INCH-POUND
MIL-PRF-123B
AMENDMENT 6
30 May 2001
SUPERSEDING
AMENDMENT 5
6 July 1998

CAPACITORS, FIXED, CERAMIC DIELECTRIC,
(TEMPERATURE STABLE AND GENERAL PURPOSE), HIGH RELIABILITY,
GENERAL SPECIFICATION FOR

This amendment forms a part of MIL-C-123B, dated 6 August 1990, and is approved for use by all Departments and Agencies of the Department of Defense.

Example 6 "

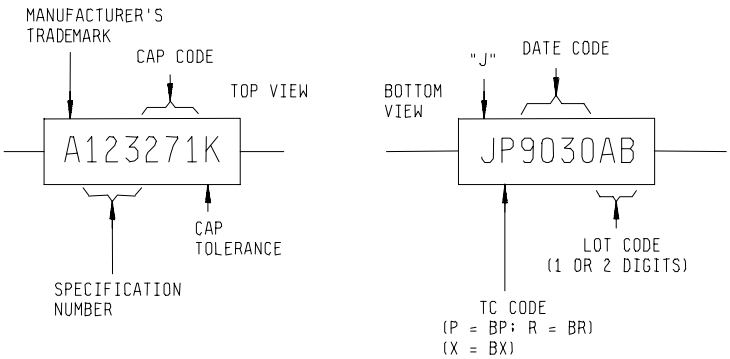
FIGURE 3, example 6, delete and substitute:

FIGURE C-7. Chip-outs. "

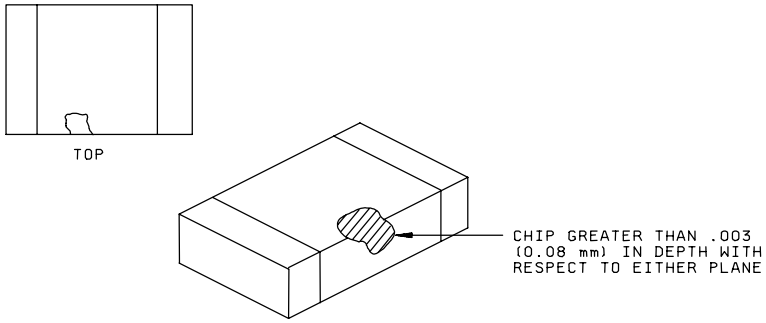
FIGURE C-7, delete and substitute:

30.2.2.d, first sentence, delete and substitute:

"Edge chip-outs shall not be greater in depth than .003 inch (0.08 mm) with respect to either plane."

FIGURE D-1. Lead-pull direction."

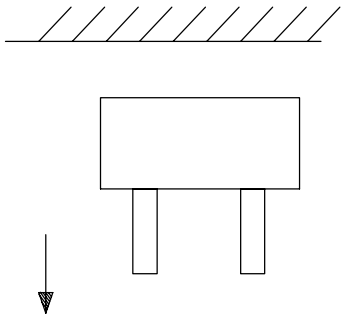
FIGURE D-1, delete and substitute:

"40.2 Axial devices. Firmly clamp both leads into the test fixture. Gradually apply an increasing force (see figure D-1) until the limits specified in table XIV are exceeded."
